Crossrail Act 2008

West Drayton Station

**Schedule 7 Plans and Specifications
Written Statement for Information**

Submission Ref: HIL/7/6/NR

GRC Cladding – not materially different to approved precast panels

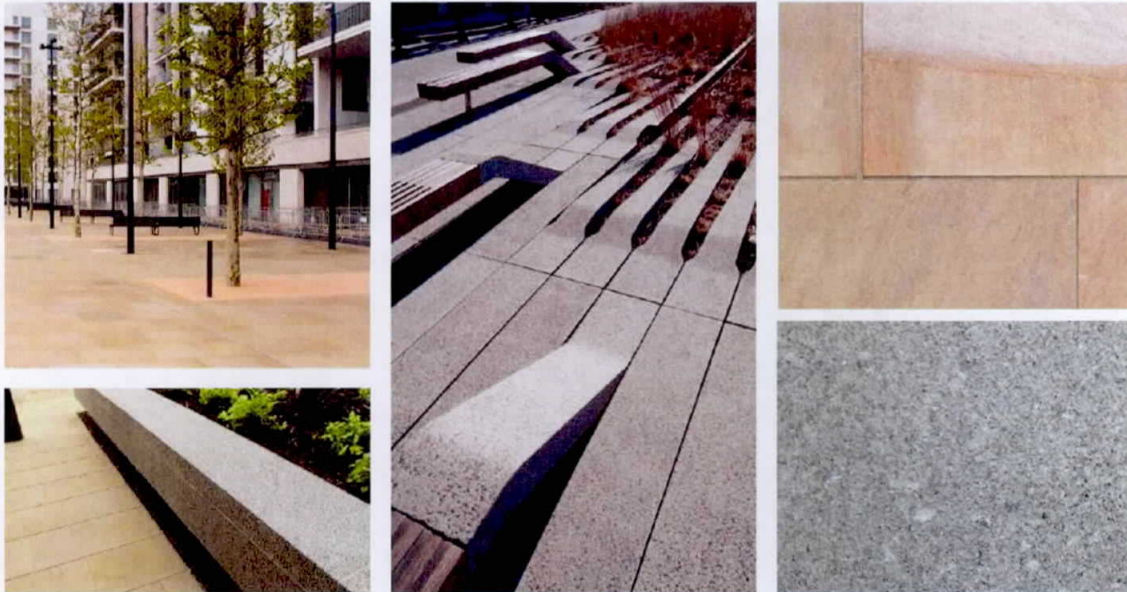
Within this submission Glass Reinforced Concrete (GRC) cladding is proposed in place of the approved precast concrete panels. In terms of character and appearance the GRC panels are not materially different to the precast concrete.
